15 December 2025

Response to Design Review Panel Comments

At the conclusion of DRP2.3, the panel provided commentary that was to be addressed in the SSDA submission to inform DPHI's consideration of design excellence. The table below provides a response to the items raised by the DRP in meeting 2.3 and should be read in conjunction with the EIS and Rezoning Report, Design Reports (**Appendix H**) and Architectural Drawings (**Appendix B**).

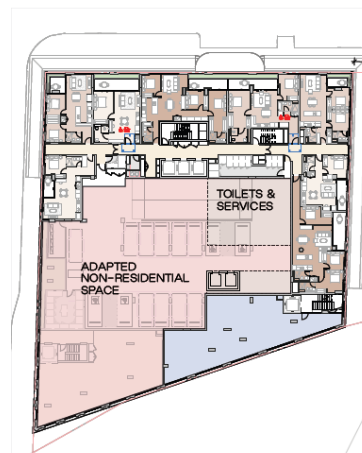
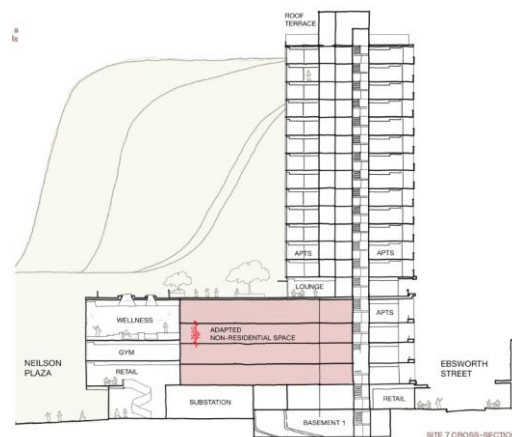
10. The Panel offers no definitive preference for the Primary or Alternative scheme, other than noting that Site 7 and 17 should read as a more consistent pair, and the Primary scheme may be pursued albeit it departs from the Urban Design Principle 3.1 and the Panel's earlier suggestions for tower height articulation	The amended DRP 2.3 massing has been pursued in the SSSDA package, which incorporates a fairly consistent height of buildings 7 and 17 (referencing Infinity), then stepping downwards for building 18 towards the Drying Green. Refer below for Urban Design Principle 3.1 and the proposed elevation.  3.1 Achieve key height consistencies across Stage 3 form • Key height datums • Solar access • Address Infinity

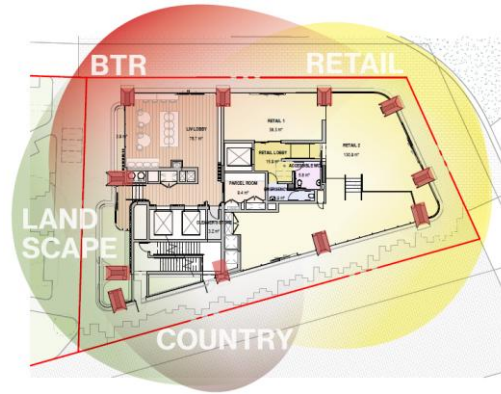
11. The Retail Uses Study has provided the Panel with a good understanding of the needs and context of the Green Square Town Centre. It is positive to see the translation of this study into the Precinct's thematically organised ground level retail layout. The Panel continues to encourage consideration of non-residential on levels above ground within the podiums to meet the objectives of the town centre aspirations.

Ground level activation is provided with non-residential uses proposed on all buildings, along with residential lobbies. Building 7 contains residential amenities within the podium level and has been designed such that a future adaptation to non-residential use could occur for the areas fronting the Plaza (refer s7.12 of the Precinct Design Report and images below).
